# CONSERVATION COMMISSION AGENDA

August 26, 2021

- Request: Issue an OOC.
3. **(7:25) Levingston Cove (Crystal lake) – NOI – park improvements – DEP File #239-901**
  - Owner: City of Newton Applicant: Luis Perez Demorizi, Open Space Coordinator

- Approve two plan sheets as the Plans of Record:
  - Site Plan 96 Lake Ave., last revised 8/2/21, Sheet 1 of 1, Merrill Engineering and Land Surveyors. – NOTE that all landscaping details on this sheet are superseded by Landscape Plan, Sheet A0-51, 7/29/21

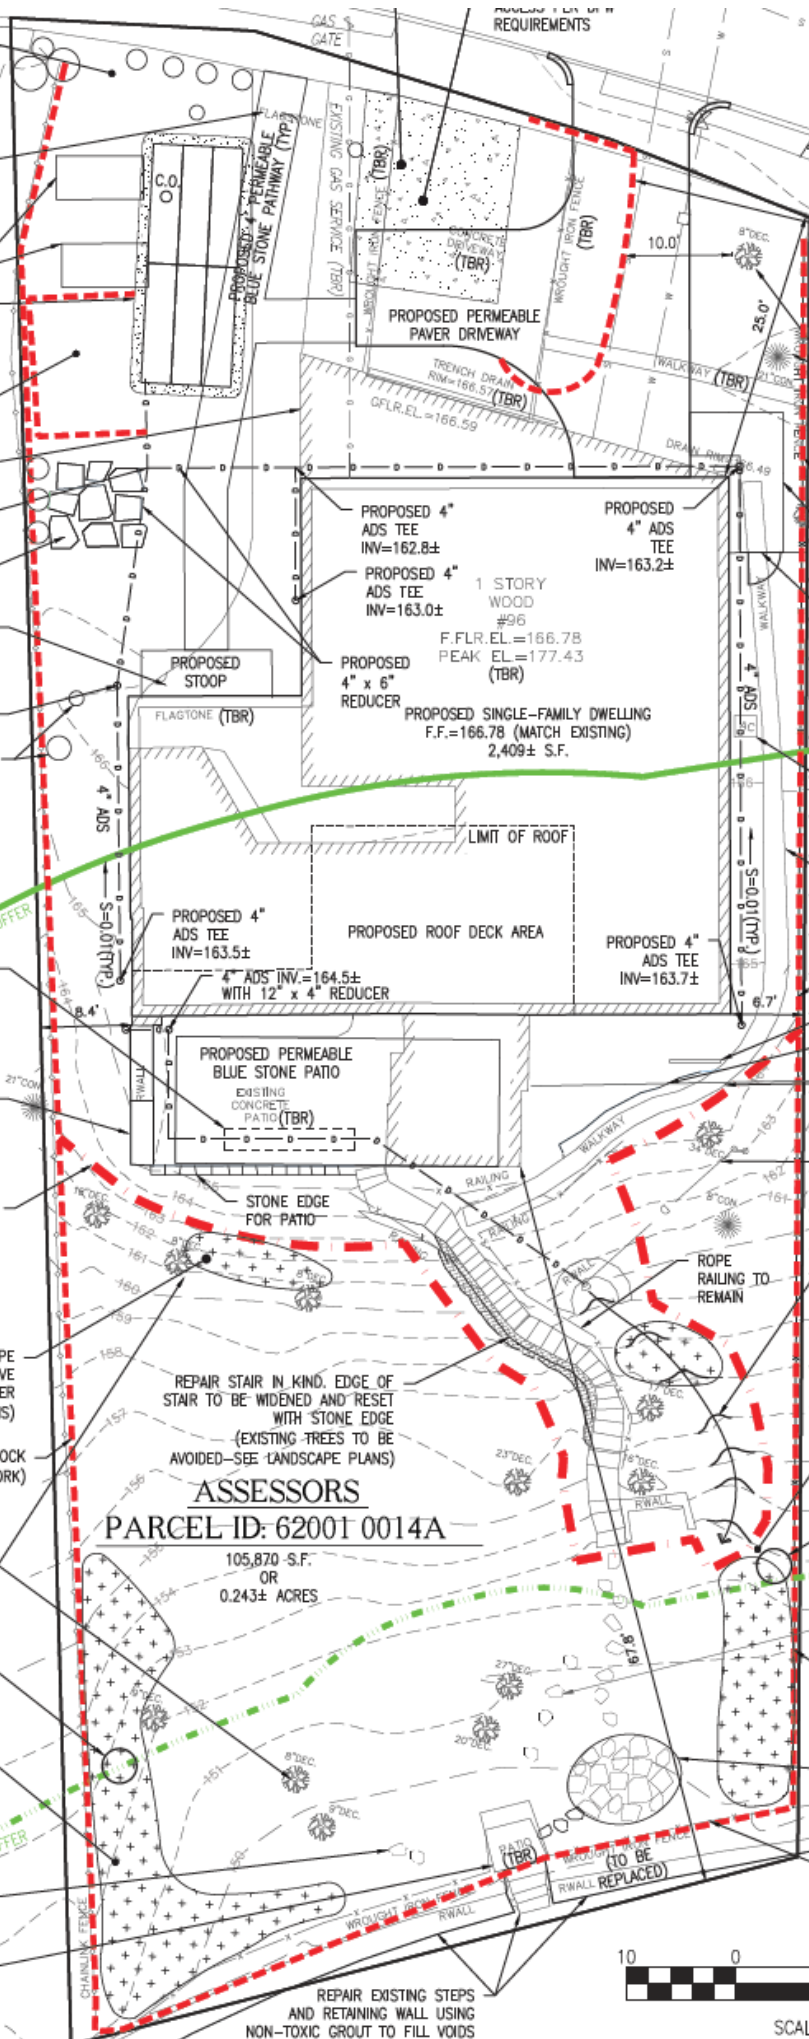
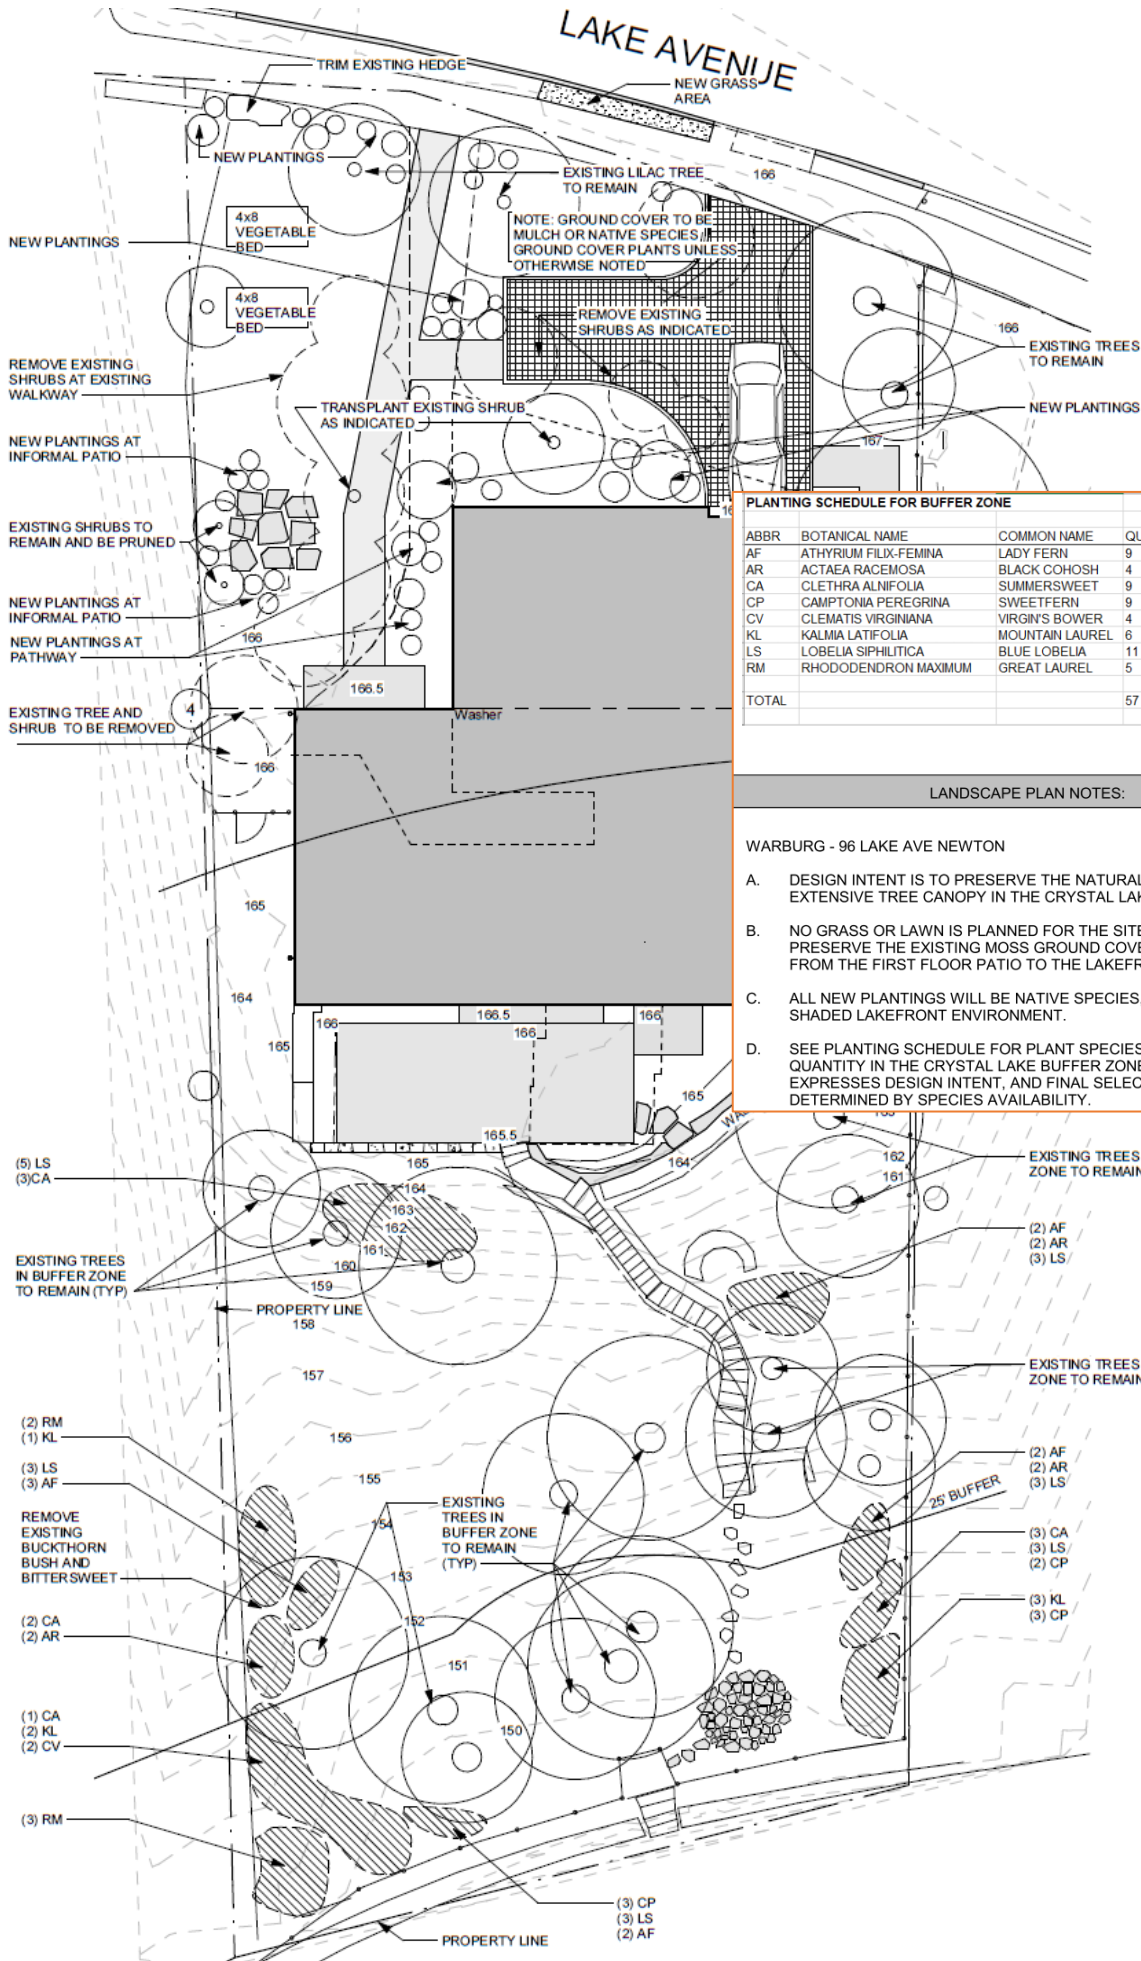
- Landscape Plan, Sheet A0-51, 7/29/21, Place Tailor, Inc.
- The stairs may be reconstructed and widened for safety purposes up to 4' wide in their current alignment and length but said reconstruction may not disturb the mature trees nearby. Grading of the adjacent slopes has not been proposed and is not hereby approved.

- The minor grading changes associated with the proposed swale are approved. The new swale must be stabilized with the New England Wetland Plants Detention Basin mix and, if necessary, and erosion control blanket.

- Mitigation plantings must be installed as per the approved plans and at least 75% of shrubs and 75% aerial coverage of groundcover must survive after 2 growing seasons.
